UNITED STATES PATENT AND TRADEMARK OFFICE

APPLICATION NO.	FILING DATE	FIRST NAMED INVENTOR	ATTORNEY DOCKET NO.	CONFIRMATION NO.
10/009,936	12/10/2001	Gilles Bos	33900-90PUS	4569

Office Action Summary

DETAILED ACTION

**FIG. 5**

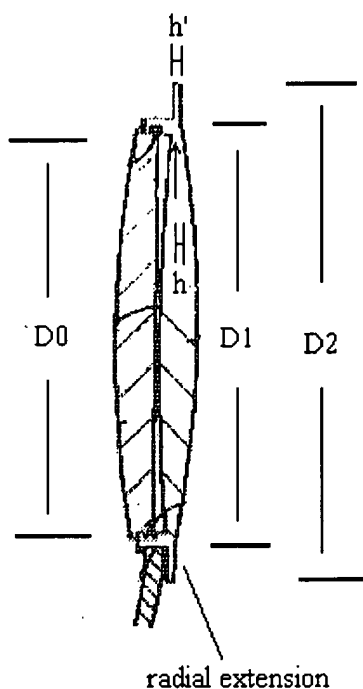
8. Claims 2-9 are rejected, as best understood, under 35 U.S.C. 102(b) as being clearly anticipated by Weiser (US 5,713,958 A; cited in previous PTO-892).

As seen in Figure 5 (see Figure 5 below), Weiser discloses an intraocular implant comprising an optical portion having an optical axis, a periphery having at least one connection zone, an anterior optical surface (lens 92), a cylindrical peripheral surface (ring 94) having a diameter and *a length h* (emphasis added) measured parallel to said optical axis, a posterior optical surface (lens 90) defined by a spherical cap, at least one haptic element (haptics 16, 18) having a posterior face and a connection end for connection to a respective connection zone of said periphery of said optical portion, and at least one radial extension (see L-shaped ends formed by ring 94 and lens 90) projection out of said cylindrical peripheral surface.

Each of said radial extensions having an anterior face, a side face, and a posterior face. Said side face of said radial extension disposed on a ruled surface having a diameter D2, said diameter D2 being greater than said diameter D1, said side face having *a length h'* (emphasis added) measured parallel to said optical axis and being substantially equal to said length *h* of the cylindrical peripheral surface. The connection end of the haptic element is connected to the periphery of said optical portion via said anterior face of said radial extension outside said anterior optical surface of said optical portion. Each radial extension constitutes a step formed by the offset between said posterior optical surface of said optical portion and said posterior face of each said haptic element. Each said side face of each said radial extension forms a square-edged portion with said posterior face of said radial extension. The anterior optical surface is bounded by a circle having a diameter D0 that is less than the diameter D1.

c. Applicants argue, "it is the length of ring 94 which must be compared to the defined length h of the cylindrical surface". Examiner respectfully disagrees. The claimed language requires: (i) a cylindrical peripheral surface having a length h , (ii) a radial extension having a side face having a length h' , and (iii) length h being substantially equal to length h' . First of all, where is the demarcation or boundary between the "anterior optical surface 24", the "posterior optical surface 26", the "radial extensions 30, 32", and the "cylindrical peripheral surface having a diameter"? Second, the claim requires *a length*, which could be broadly interpreted as any portion along the "cylindrical peripheral surface" thickness and any portion along the "radial extension having a side face having a length h' " thickness. Third, both lengths (i.e., " h " and " h' ") are substantially equal. These limitations are shown in Figure 5 of Weise '958.
